50 THE DRIVEWAY

DESIGN PRESENTATION - REZONING APPLICATION RESUBMISSION

JANUARY 19TH 2021

MAIN CHANGES / RESPONSES TO FEEDBACK

BUILDING SETBACK ALONG LEWIS TO RESPECT 3M

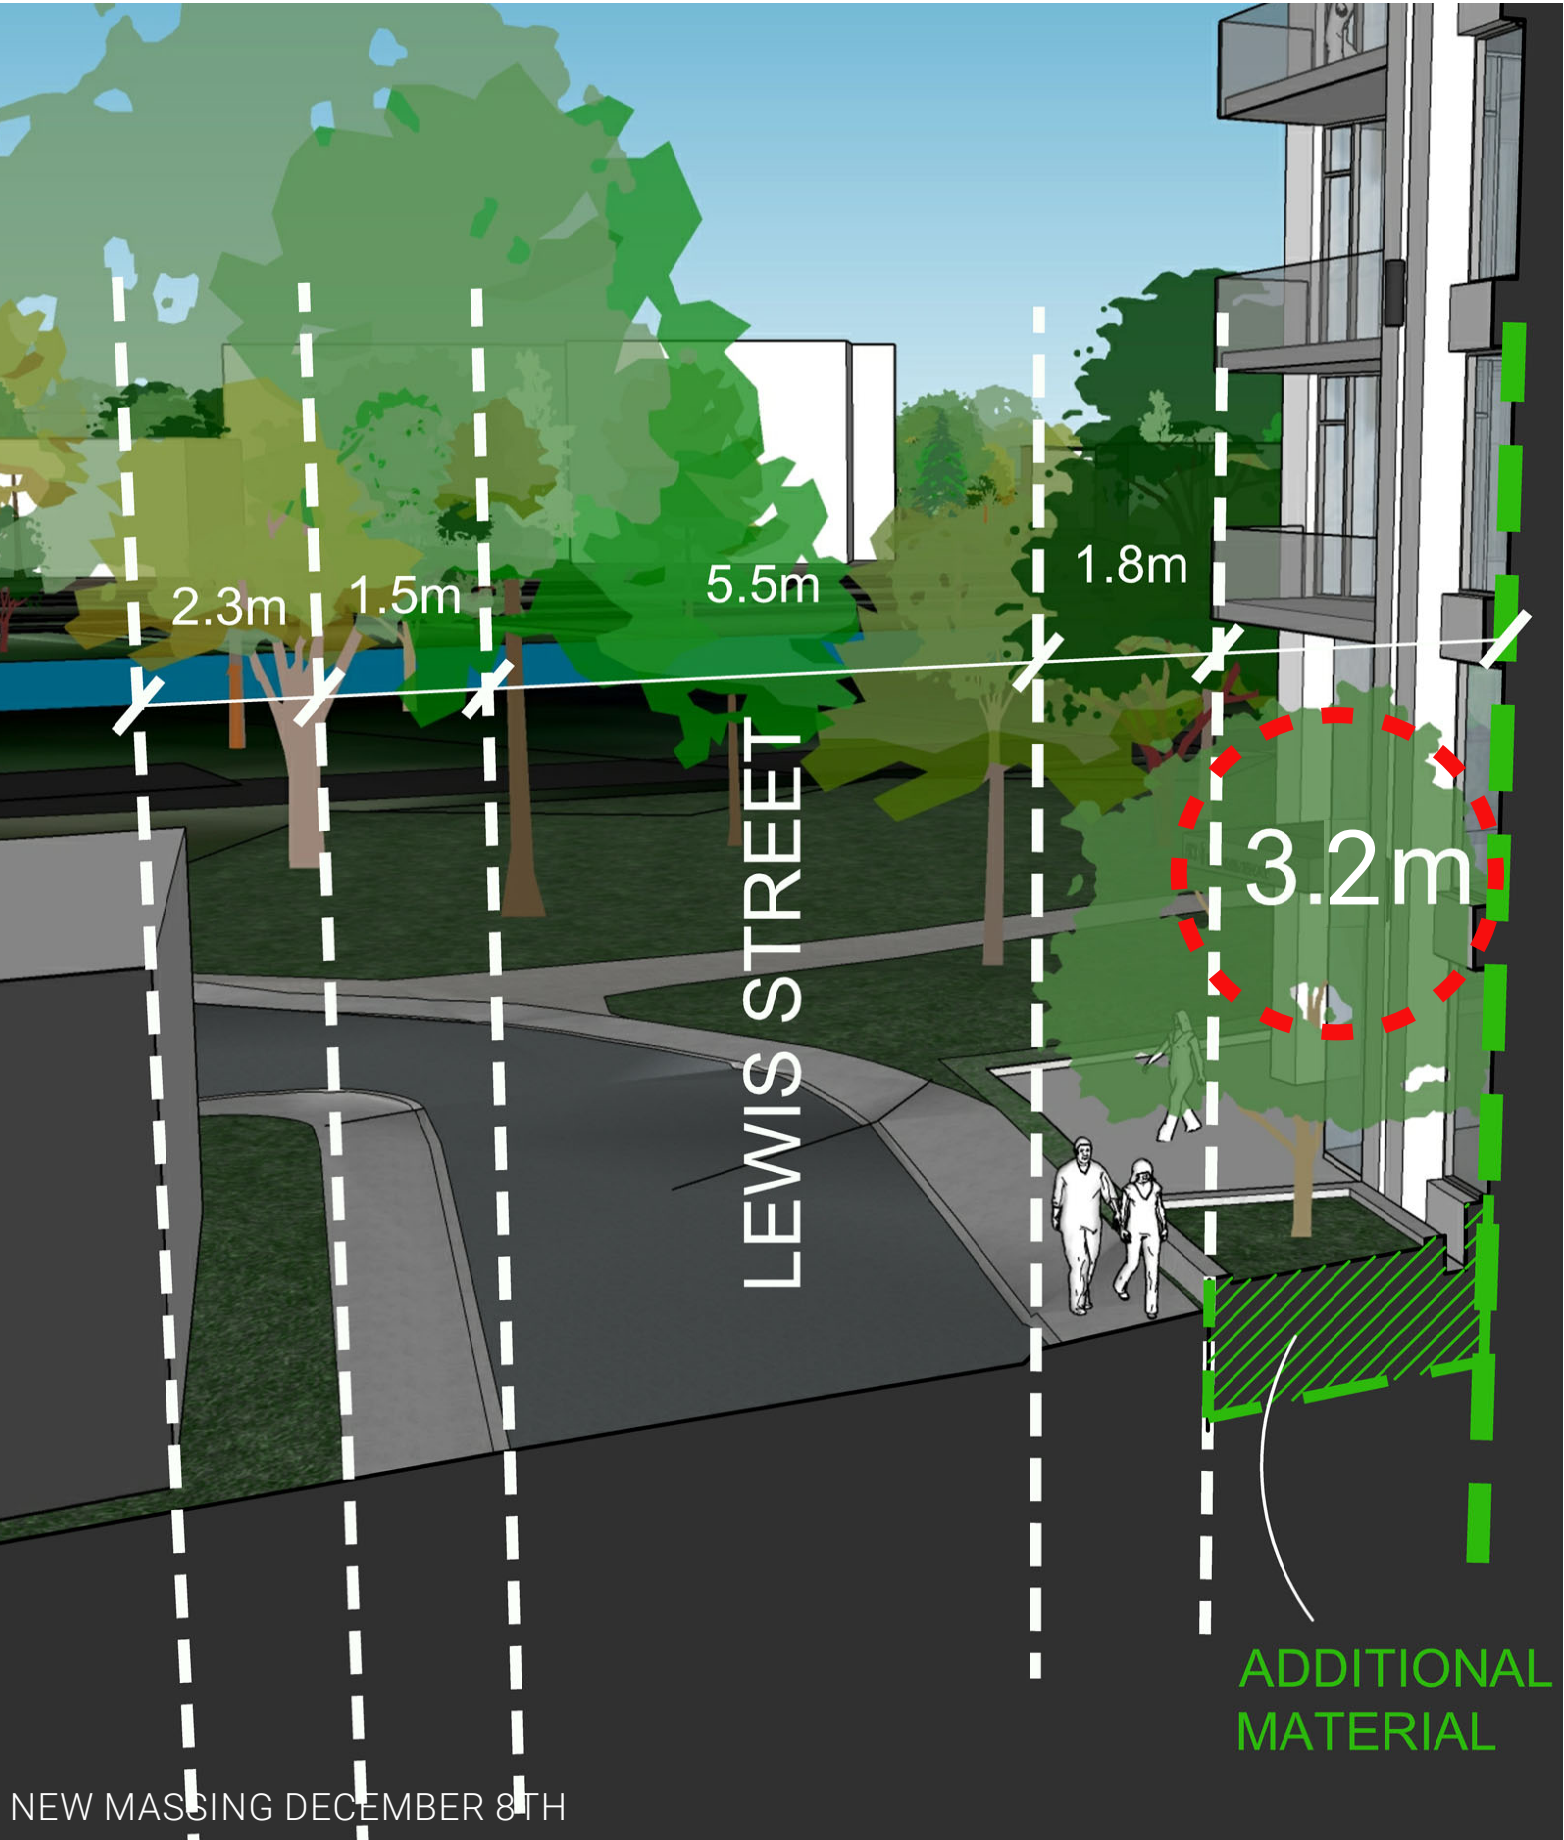
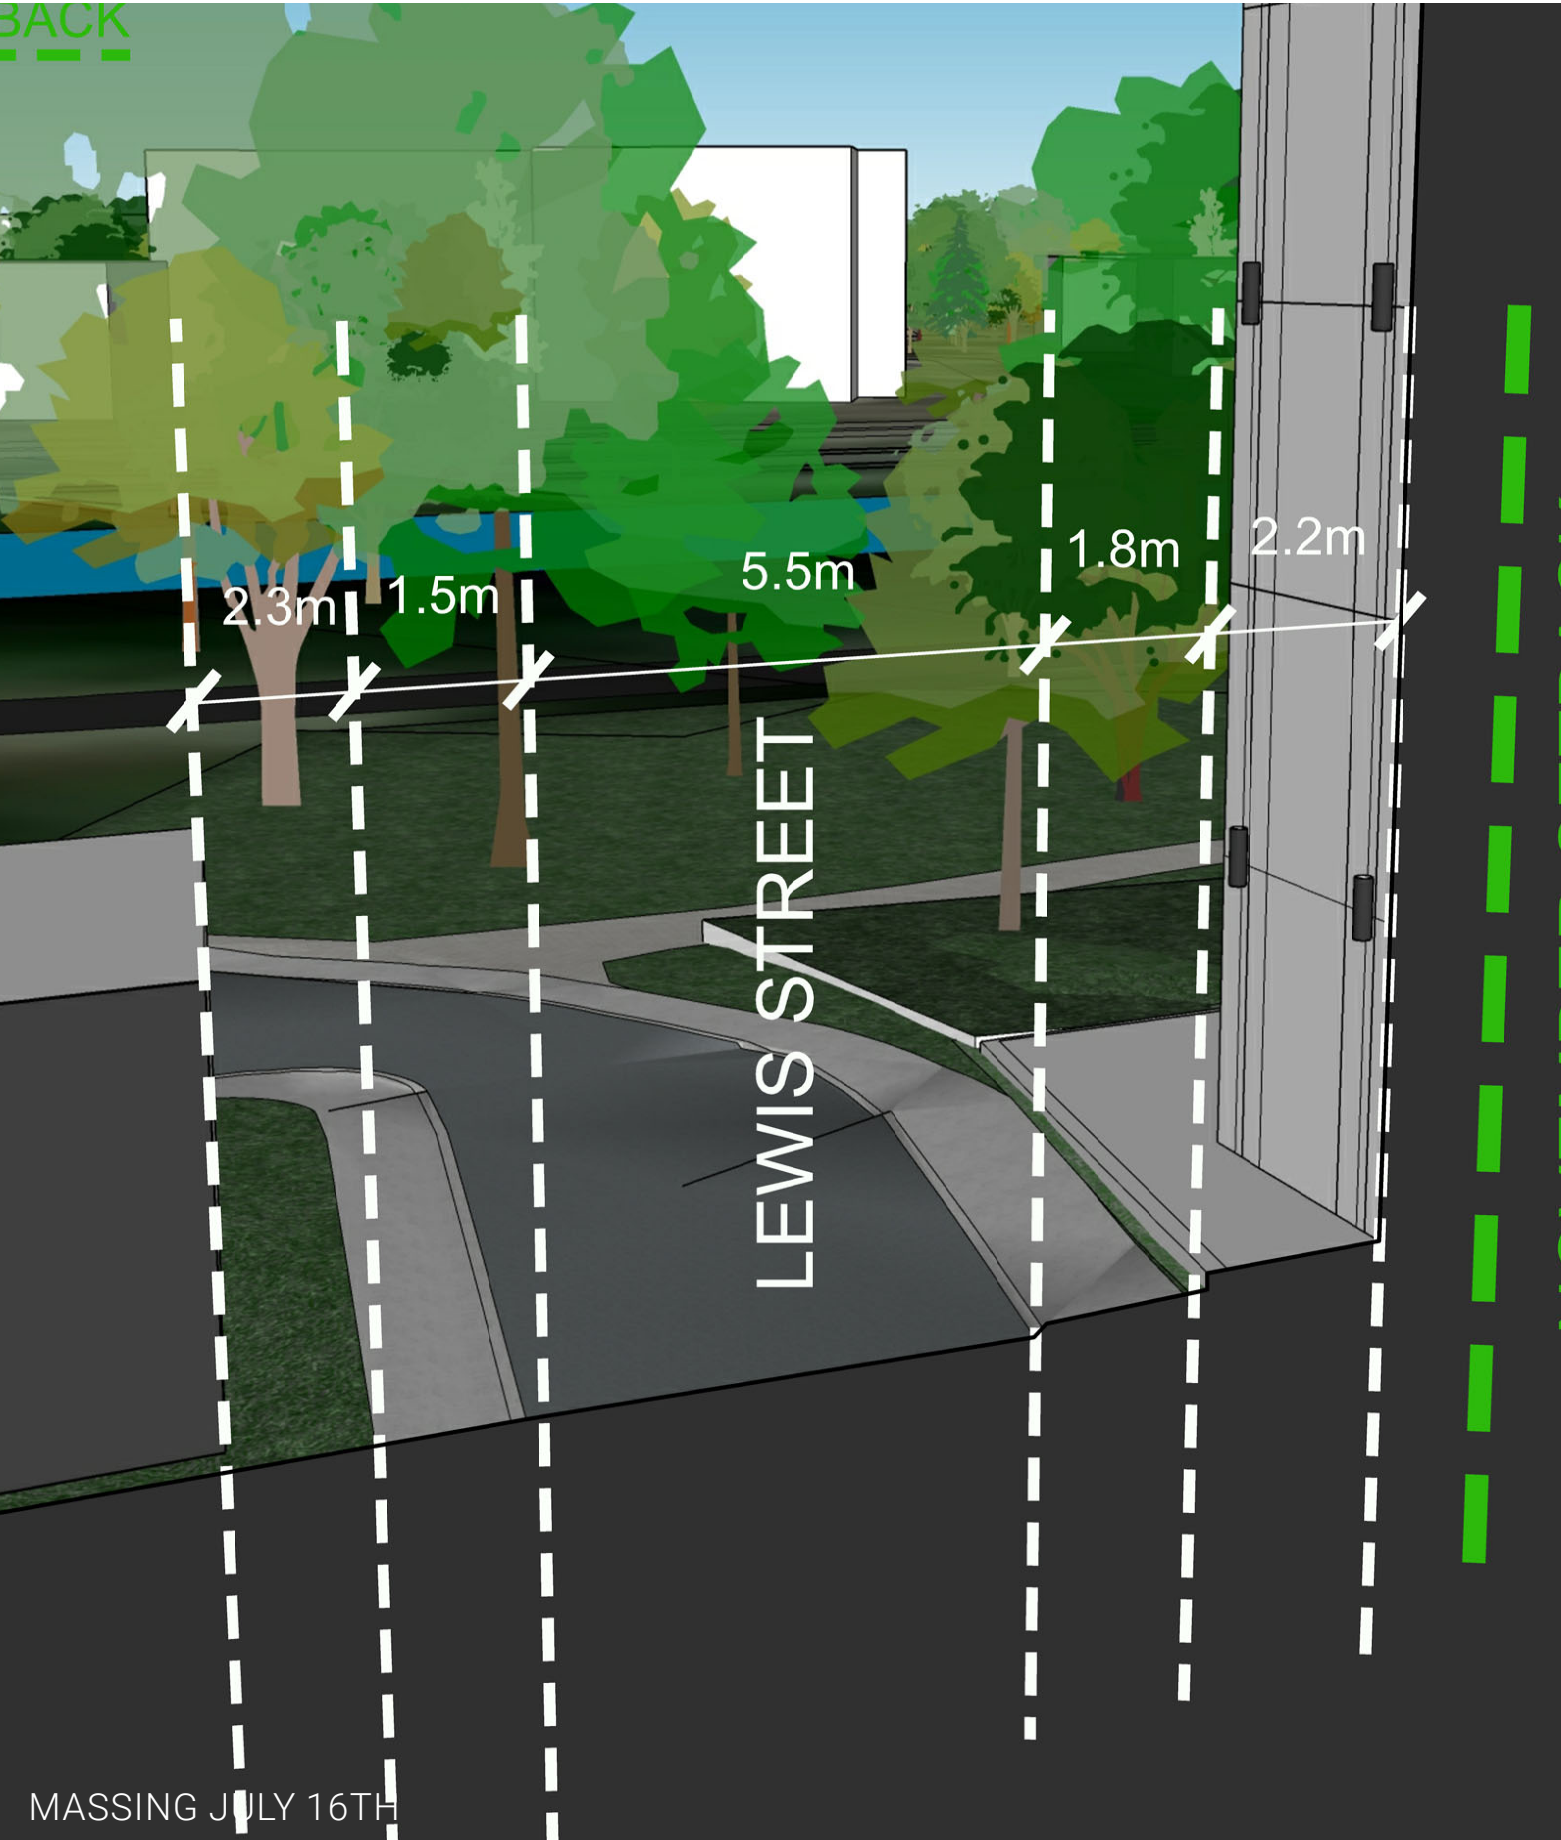
- 1 - BUILDING FOOTPRINT IS PULLED BACK FROM LEWIS STREET TO RESPECT THE 3M SETBACK
 -
- 2 - PARKING GARAGE HAS BEEN PULLED BACK ALONG LEWIS TO ALLOW FOR PROPER TREE PLANTING WITH SIGNIFICANT SOIL VOLUME
 -
- 3 - PARKING STRUCTURE AT LEWIS & THE DRIVEWAY CARVED OUT TO RETAIN LINDEN ON NCC PROPERTY
 -
- 4 - LOADING BAY IS MOVED AWAY FROM ABUTTING TOWNHOMES TO ALLOW FOR A PROPER LANDSCAPE BUFFER

WEST FACADE PUSHED EAST BY 0.5M

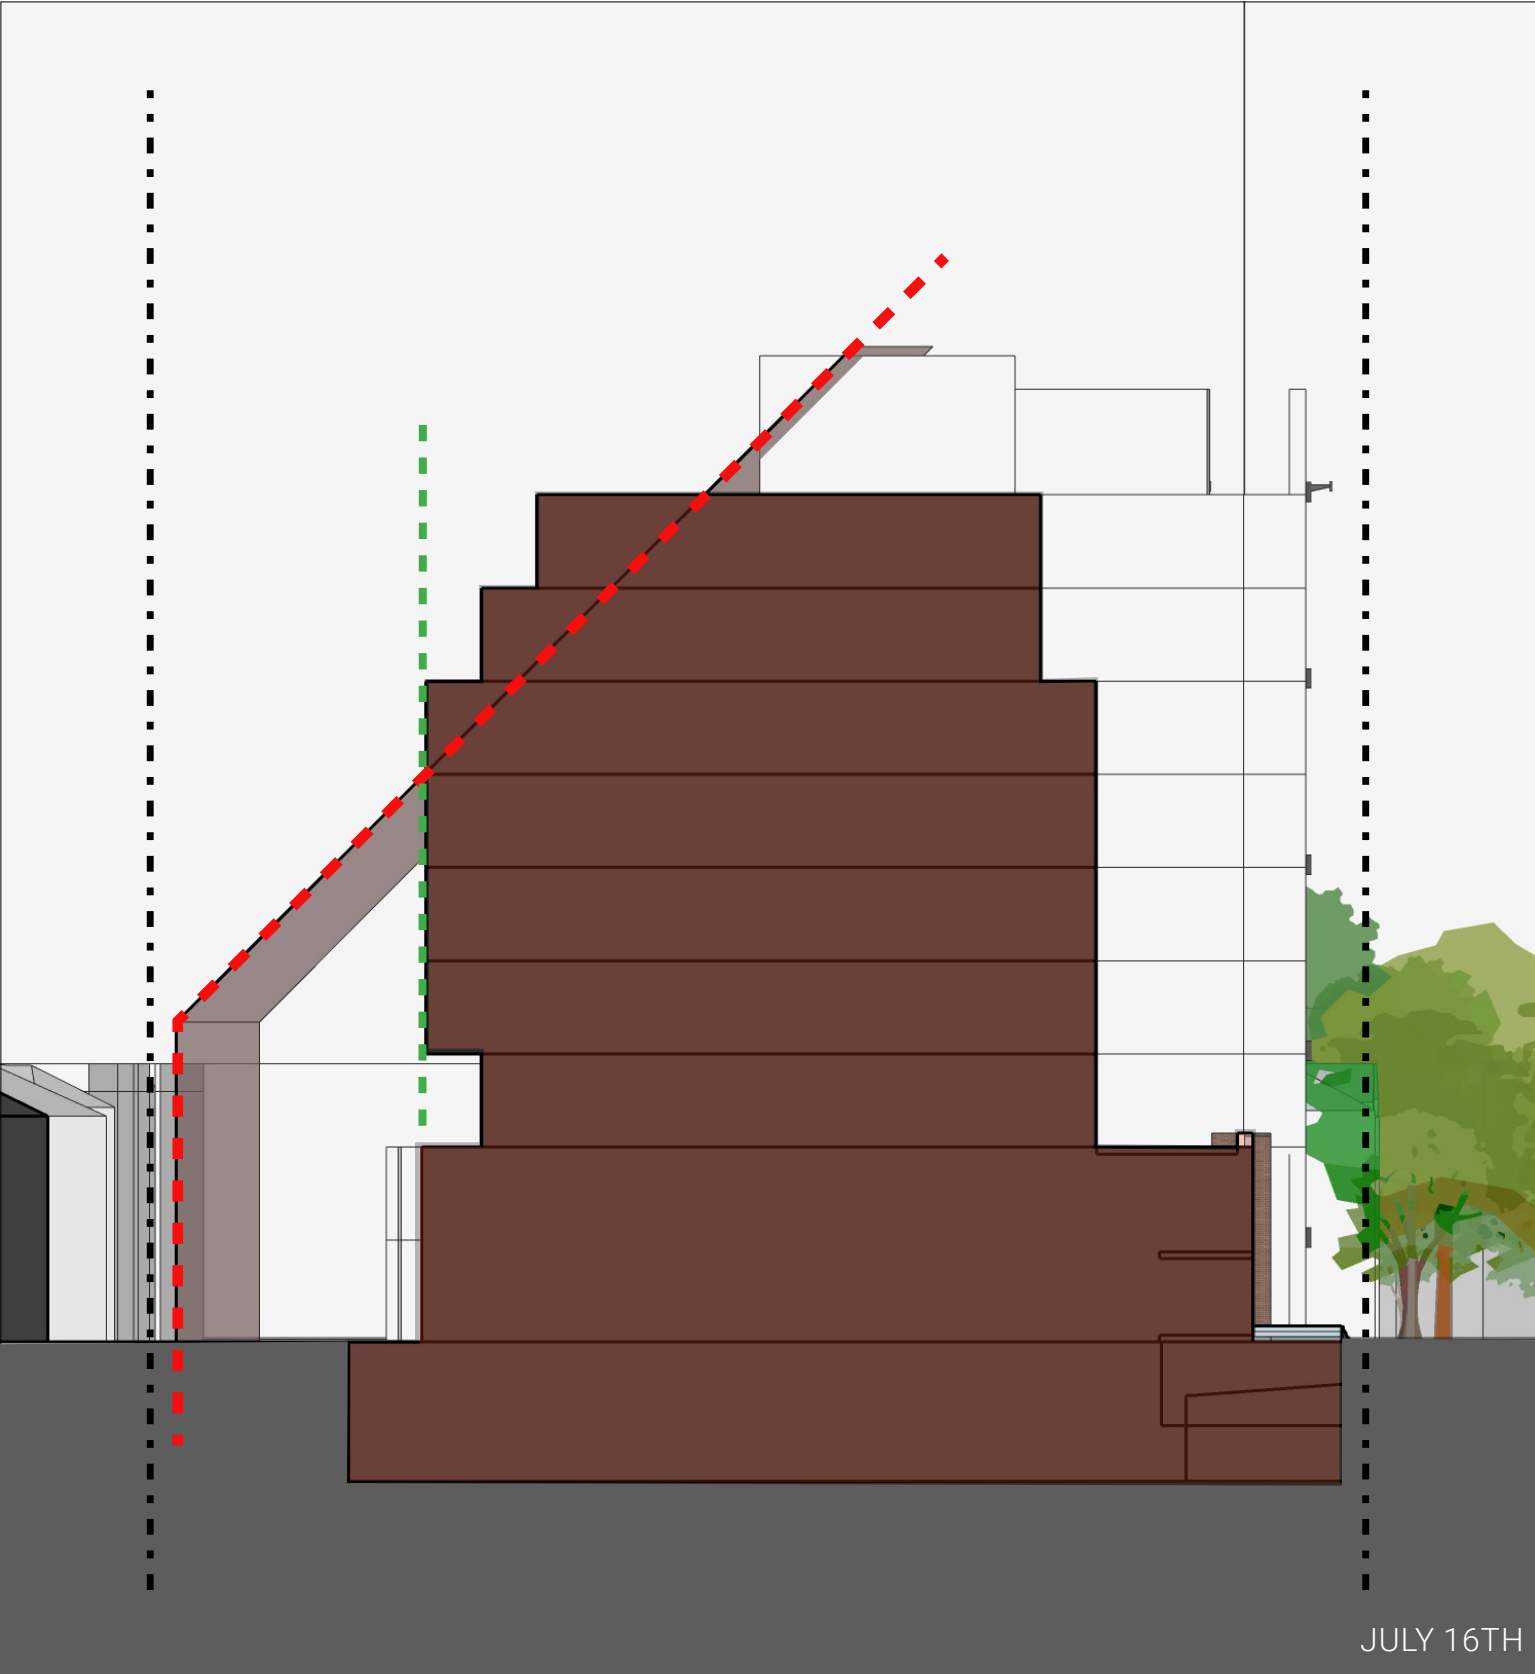
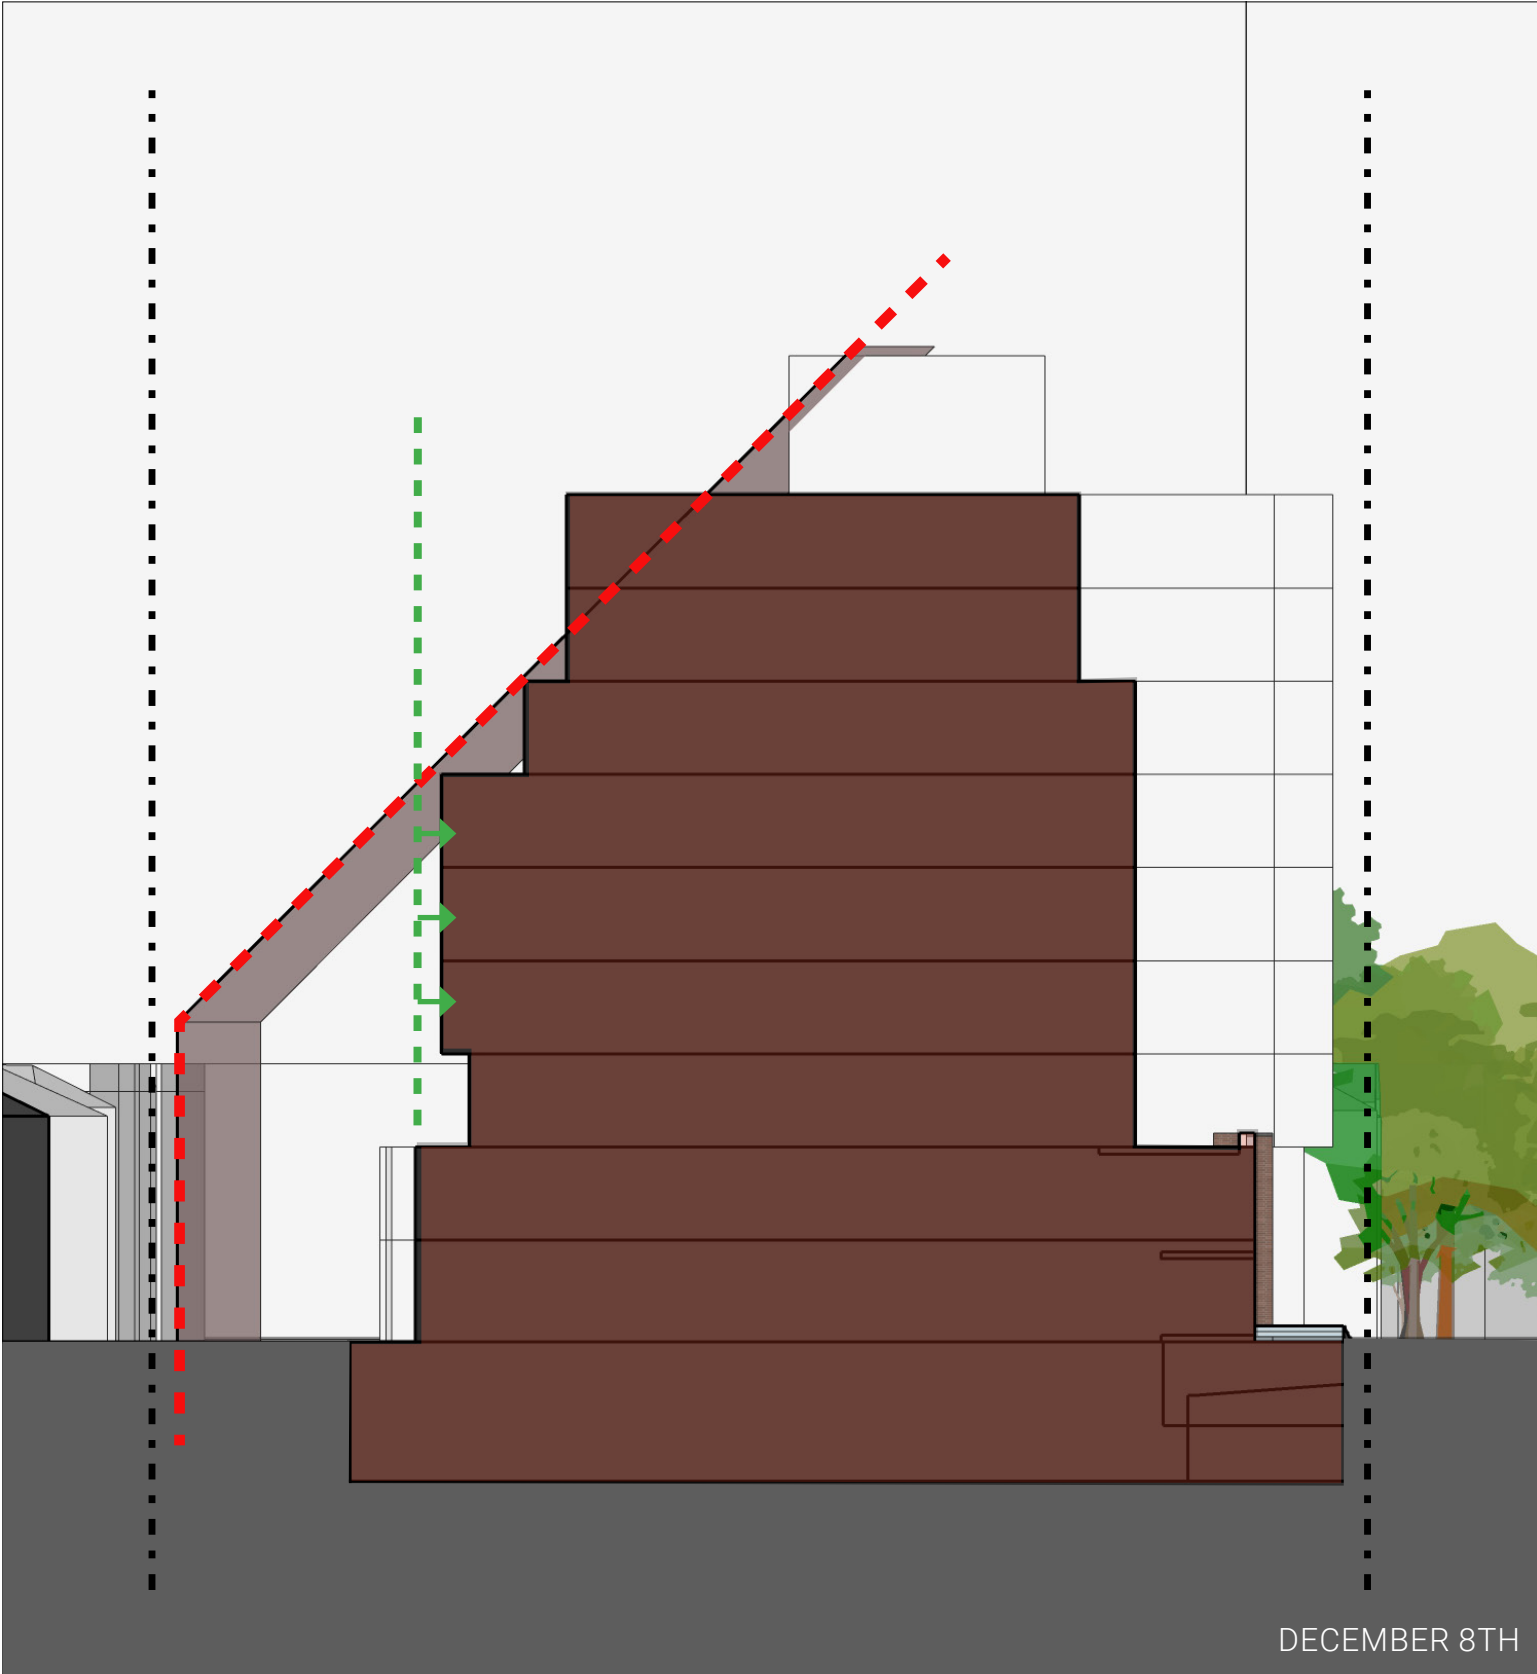
- 1- BUILDING FOOTPRINT IS PULLED BACK FROM LEWIS STREET TO RESPECT THE 3M SETBACK
 -
- 2 - ENTIRE WEST FACADE ABOVE THE PODIUM IS SHIFTED EAST BY AN ADDITIONAL 0.5M
 -
- 3 - STEP-BACKS OCCURRING 1 LEVEL EARLIER (AFTER 6TH RATHER THAN 7TH FLOOR) AND ARE PULLED FURTHER IN BY 1M TO BETTER RESPECT THE INTENT OF THE ANGULAR PLANE
 -
- 4 - EAST FACADE ABOVE HERITAGE BUILDING SHIFTED EAST BY 1M & HERITAGE PULLED CLOSER TO PROPERTY LINE BY 0.3M (RESPECTING THE 1.2M SIDE YARD SETBACK)

NEW PROPOSED WEST FACADE POSITION
